V2500 Propulsion System - Nacelle **SERVICE BULLETIN**

Subject: Transmittal of Revision 1 to Service Bulletin Number V2500-NAC-78-0144

NACELLE - EXHAUST - ACTUATOR FAIRINGS, THRUST REVERSER - REPLACEMENT OF

V2500-NAC-78-0144

Actuator Fairing Replacement and Installation Modification
Figure 2 (Sheet 2)

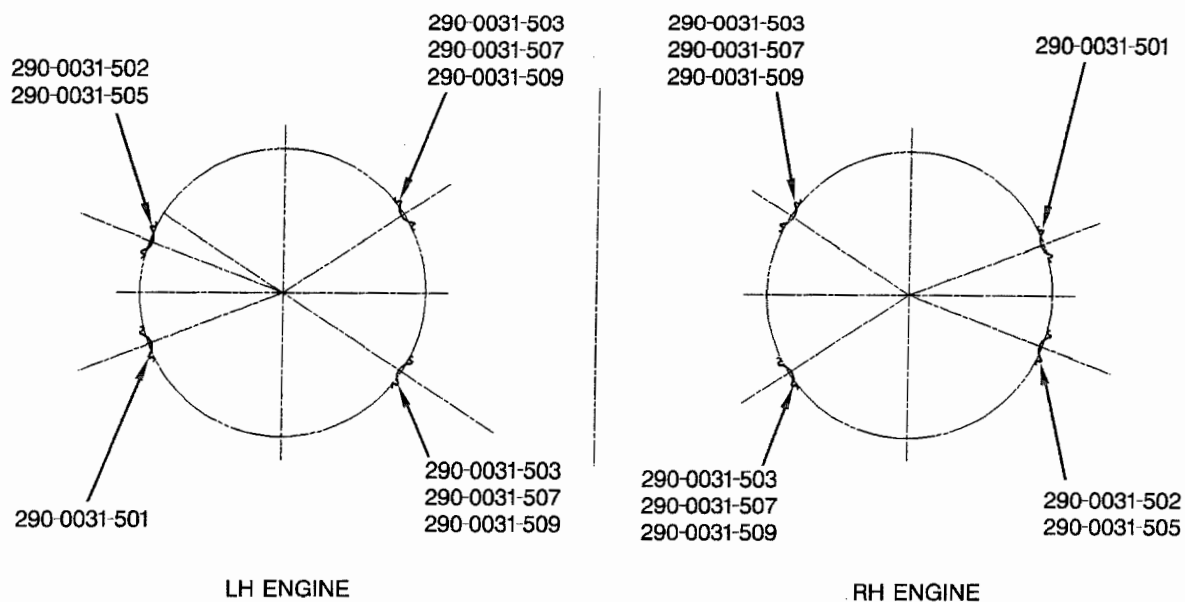
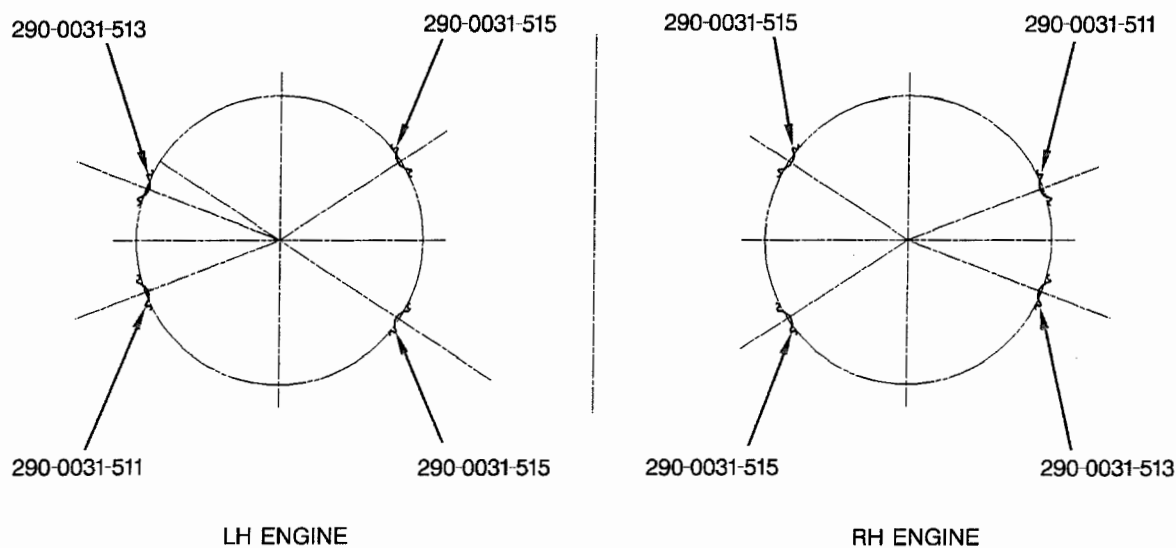
Replace the existing thrust reverser actuator fairings with fairings of a design less susceptible to cracking.

The thrust reverser actuators and actuator fairings are removed. The forward and aft attach points for the fairings are modified to accept the new fairings (which have one less attaching bolt at each end). The new actuator fairings are installed. The actuators are installed and the thrust reverser rigging is checked.

- (1) Install the new 290-0031-511 and 290-0031-513 thrust reverser outboard actuator fairings with the washers and bolts. Torque the bolts to 75-85 in-lbs (8,5-9,6 Nm). Refer to Figure 2 (sheets 2, 3, and 4).
- (2) Install the new 280-0031-515 thrust reverser inboard actuator fairings with the washers and bolts. Torque the bolts to 75-85 in-lbs (8,5-9,6 Nm). Refer to Figure 2 (sheets 2, 3, and 5).

Actuator Fairing Replacement and Installation Modification
Figure 2 (Sheet 5) .

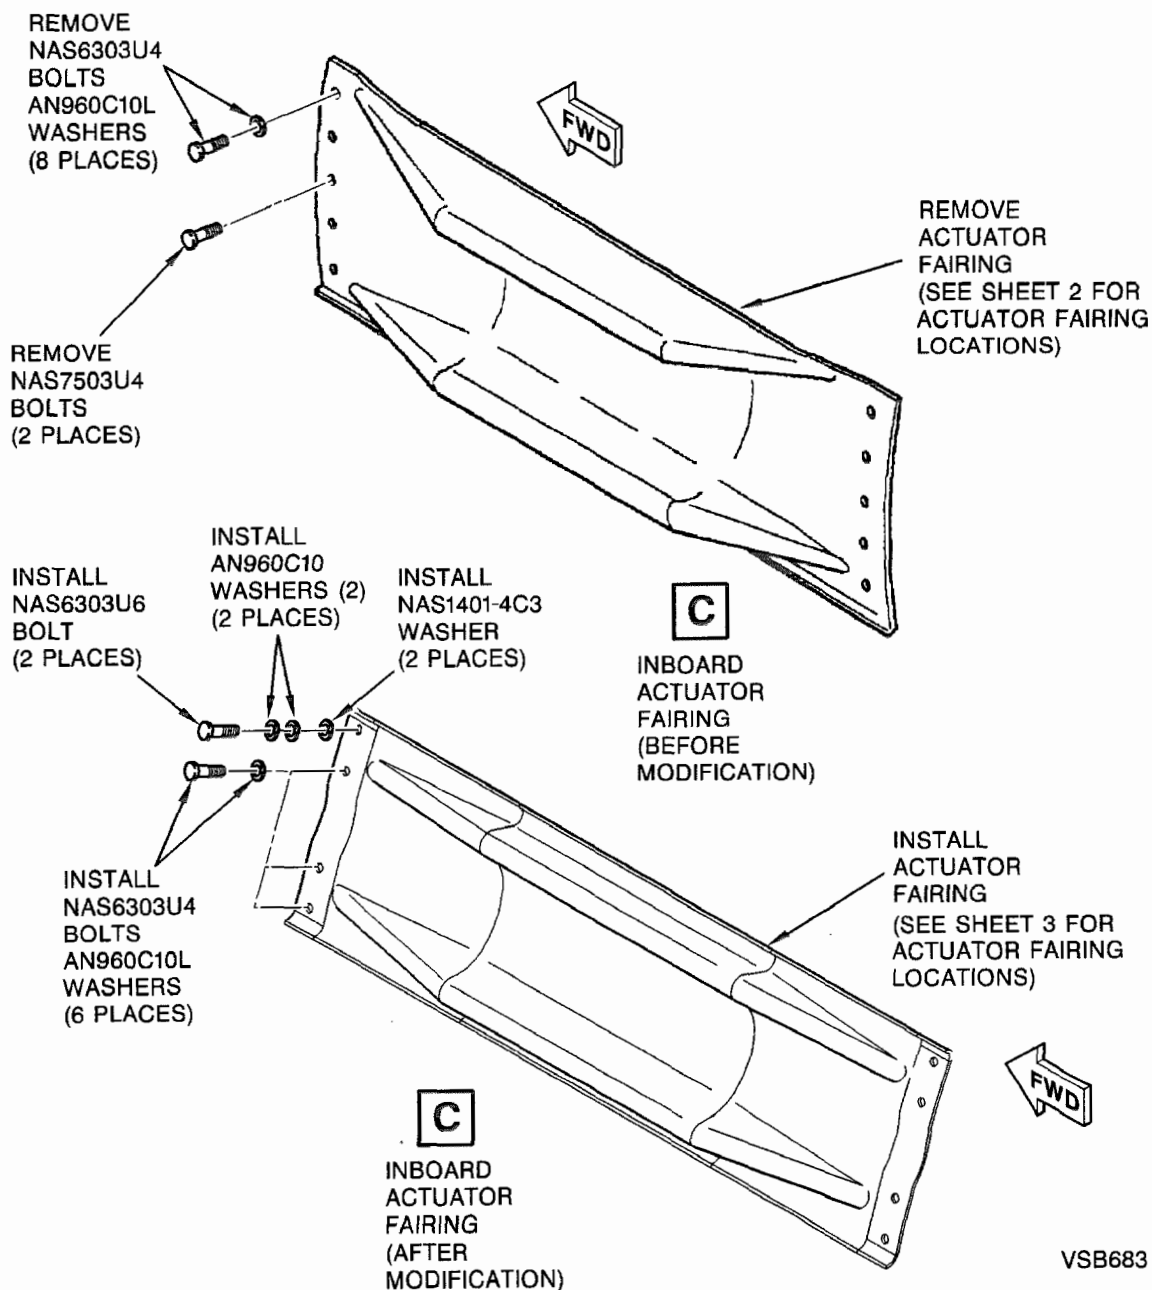
- (2) Remove the bolts, washers, and outboard thrust reverser actuator fairings. Discard the center NAS7503U4 bolt at each end of the fairings. Refer to Figure 2 (sheet 4).
- (3) Remove the bolts, washers, and inboard thrust reverser actuator fairings. Discard the center NAS7503U4 bolt at each end of the fairings. Discard one NAS6303U4 and AN960C10L washer at each end of the fairings. Refer to Figure 2 (sheet 5).

Actuator Fairing Replacement and Installation Modification
Figure 2 (Sheet 6)

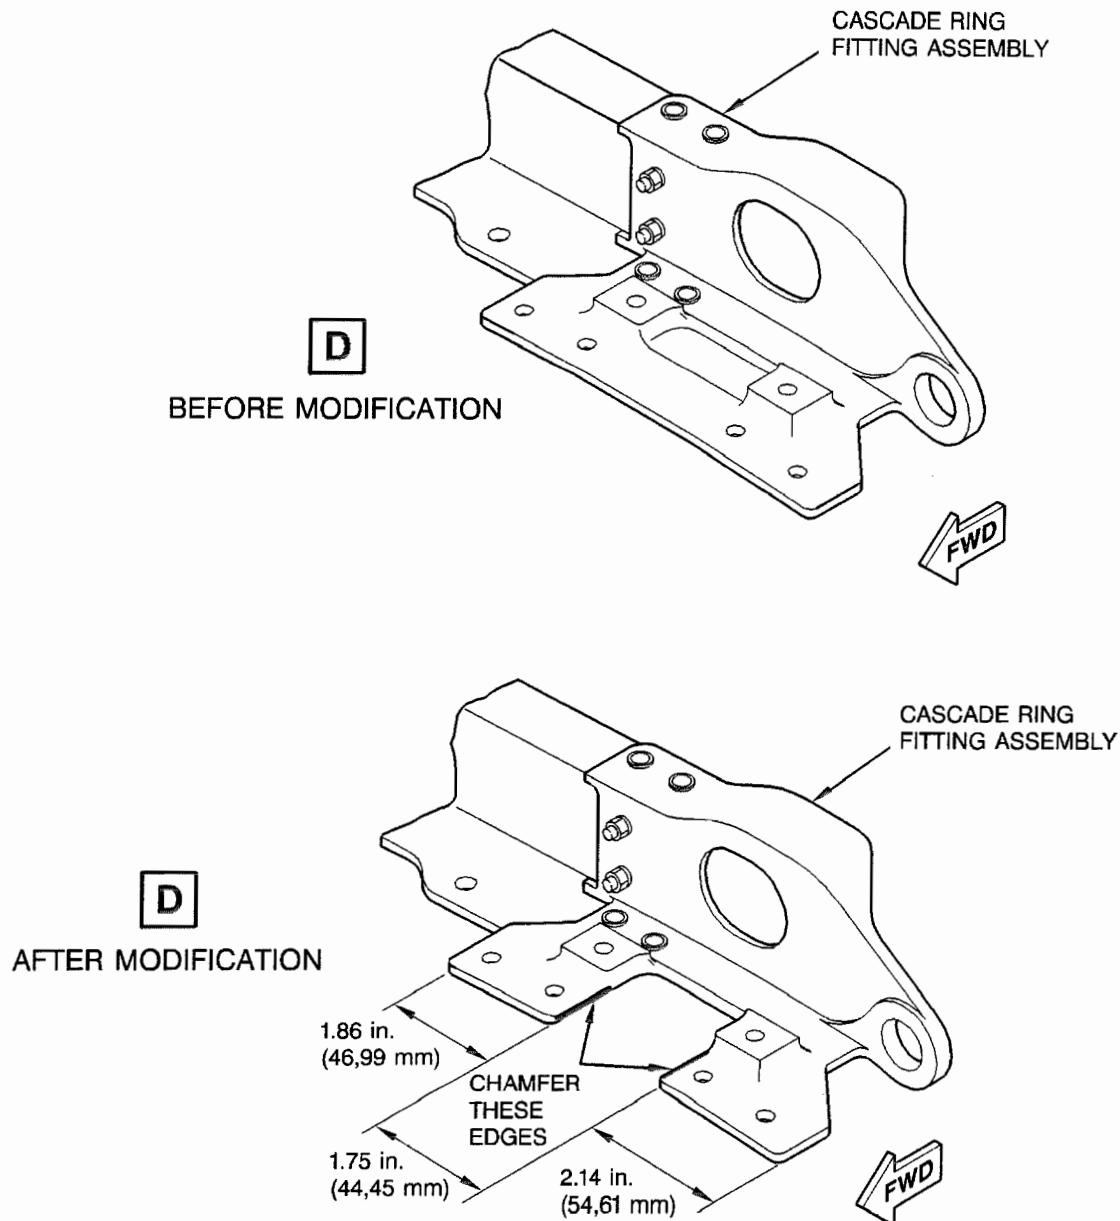
- (1) Remove material from the aft cascade support ring fittings as shown in Figure 2 (sheet 6).
- (2) Modify the outboard adapter plate assembly.
 - (a) Remove the center nutplate from each outboard adapter plate assembly. Refer to Figure 2 (sheet 7).
- (3) Modify the inboard adapter plate assembly.
 - (a) Remove the rivets and the two NAS1779C3 nutplates from the inboard adapter plate assembly as shown in Figure 2 (sheet 8)

Actuator Fairing Replacement and Installation Modification
Figure 2 (Sheet 8)

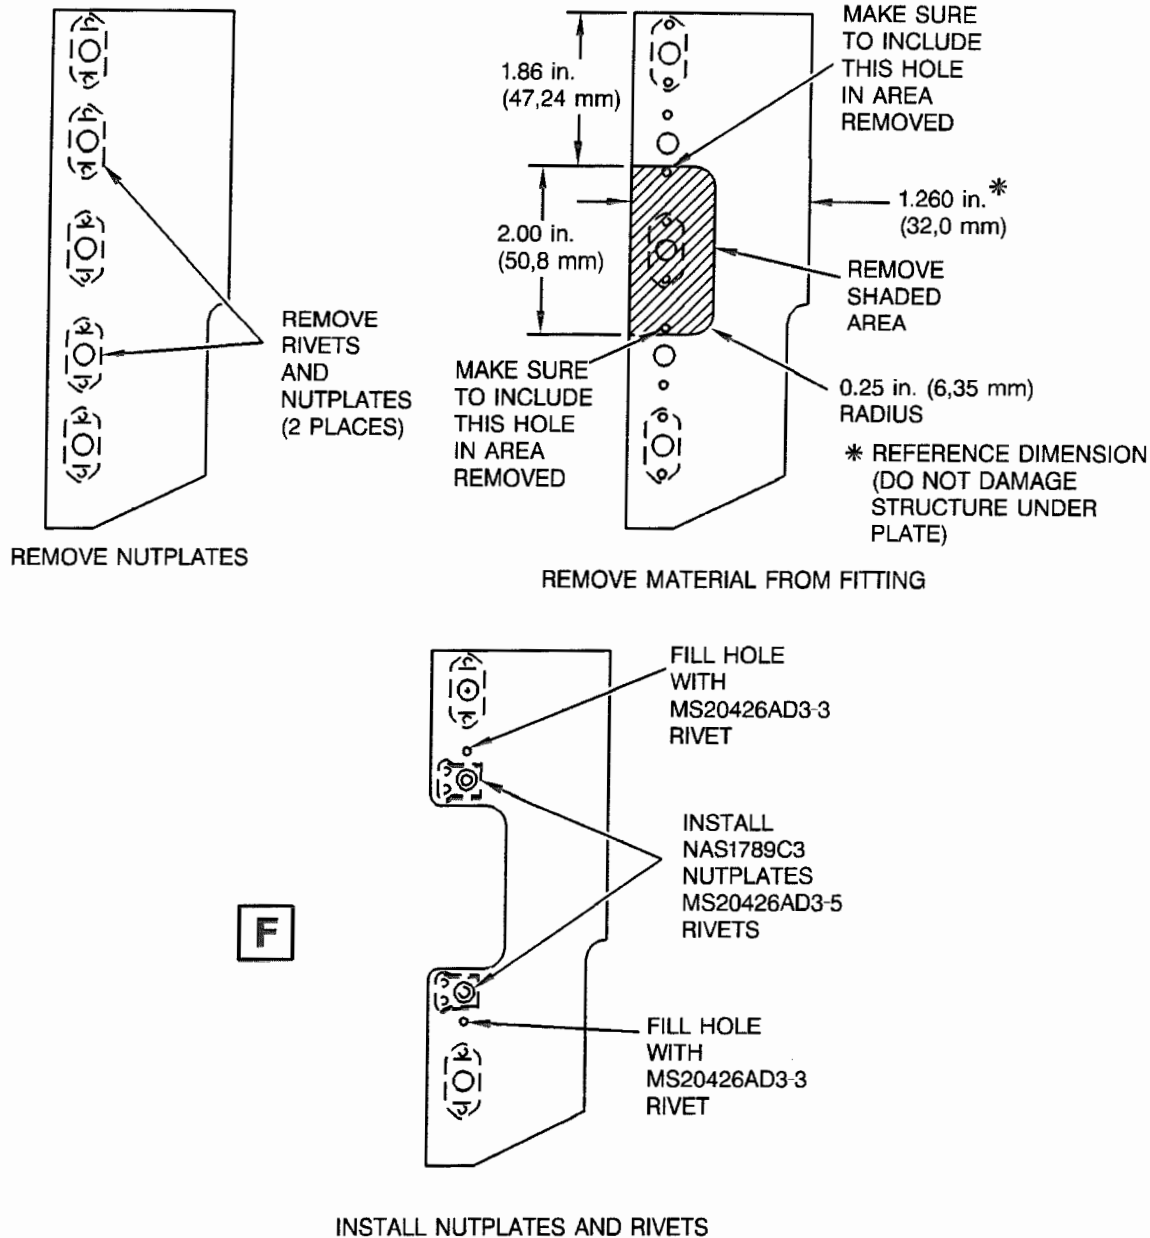
- (b) Remove material from the inboard adapter plate assembly as shown in Figure 2 (sheet 8). Use the dimensions in the Figure for reference. Make sure to remove the two indicated rivet holes. Do not damage the structure under the adapter plate.
- (c) Put the NAS1789C3 nutplates into position shown in Figure 2 (sheet 8) and drill new rivet holes.

- (f) Mix the catalyst (CoMat 07-139), epoxy primer (CoMat 07-140), and the thinner (CoMat 07-144). Refer to the manufacturer's instructions.
- (g) Apply the primer mix to the treated surfaces of the inboard adapter plate assembly.
- (h) Cure the primer. Refer to the manufacturer's instructions.
- (i) Fill the old nutplate rivet holes with MS20426AD3-3 rivets. Wet install the rivets with primer mix.
- (j) Install the two NAS1789C3 nutplates with MS20426AD3-5 rivets as shown in Figure 2 (sheet 8). Wet install the rivets with primer mix.
